ECE/TRANS/WP.29/GRSG/76  
8 December 2009

Working Party on General Safety Provisions

**REPORT OF THE WORKING PARTY ON GENERAL SAFETY PROVISIONS  
ON ITS NINETY-SEVENTH SESSION  
(Geneva, 20 to 23 October 2009)**

**Figure 4a**  
Apparatus for testing the capability to repel fuel or lubricant  
(Dimensions in millimeters)"

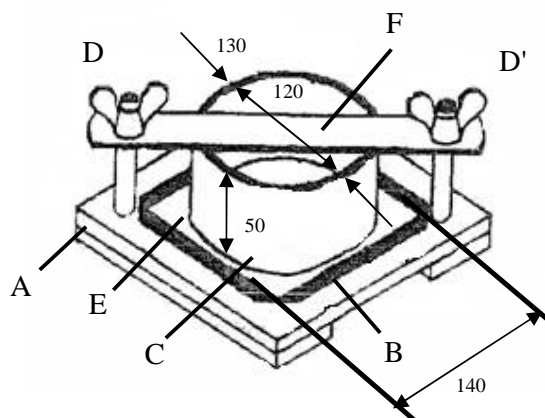
**"6.2.4.        All insulation material(s) installed in the engine compartment and any separate heating compartment shall undergo the test described in Annex 9 to this Regulation.**

**The result of the test shall be considered satisfactory if, taking the worst test results into account, the increase of the weight of the test sample does not exceed 1 g.**

"Figure 7: Definition of the area 'S' (paragraph 5.1.3.2.)

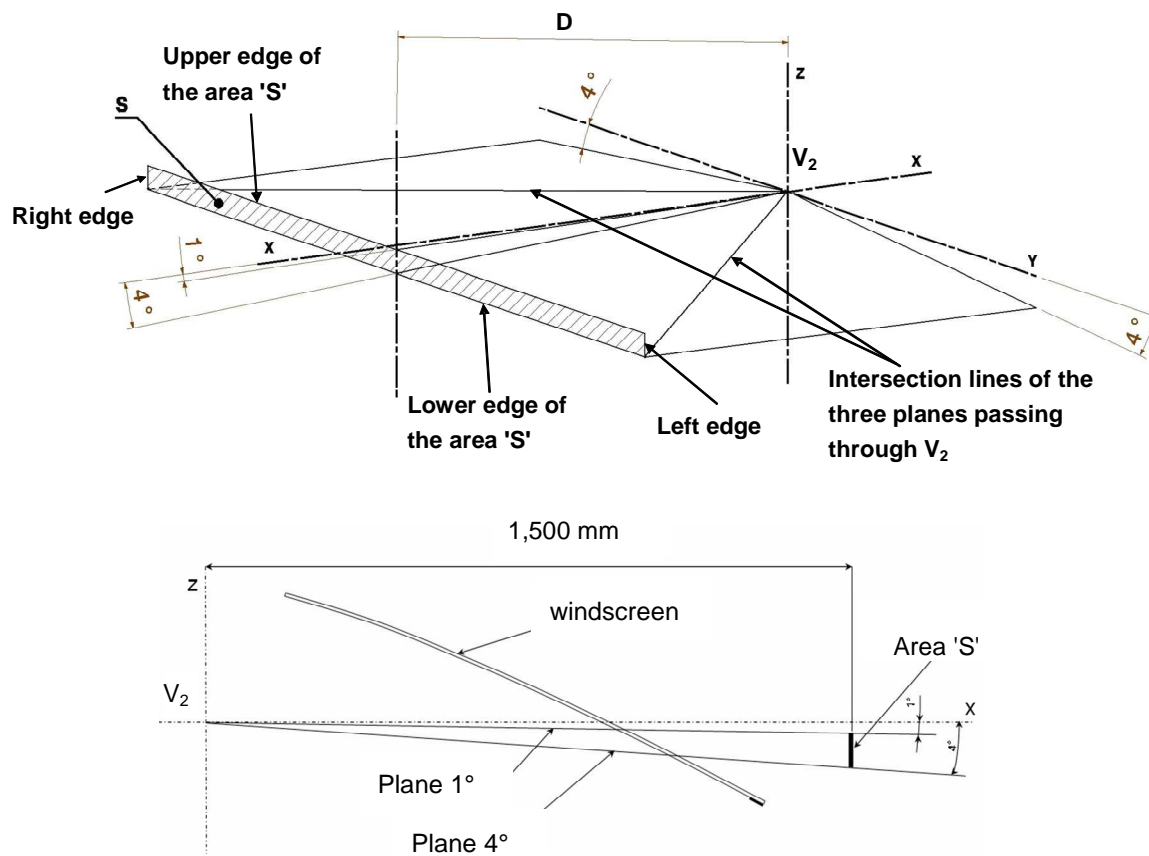
"5.1.3.2. **An obstruction between a plane through V<sub>2</sub>, and declined at least 1° below the horizontal and a plane through V<sub>2</sub> and declined 4° below the horizontal will be tolerated if the conical projection of this obstruction, starting from V<sub>2</sub>, on an area 'S' as defined in paragraph 5.1.3.2.1. does not exceed 20 per cent of this area. The steering wheel, if adjustable, shall be placed in the normal position indicated by the manufacturer or, failing that, midway between the limits of its range(s) of adjustment.**"

"5.1.3.2.1. **The area 'S' (see Annex 4, Appendix, figure 7) is a rectangular vertical area located in a plane perpendicular to the X coordinate 1,500 mm forward of the point V<sub>2</sub>. The upper edge of the area 'S' is defined by a plane passing through V<sub>2</sub> declined forward 1° below the horizontal. The lower edge of the area 'S' is defined by a plane passing through V<sub>2</sub> declined forward 4° below the horizontal. The left and right edges of the area 'S' are vertical and generated from the intersection lines of the three planes declined 4° as defined in paragraph 5.1.2.2. above.**
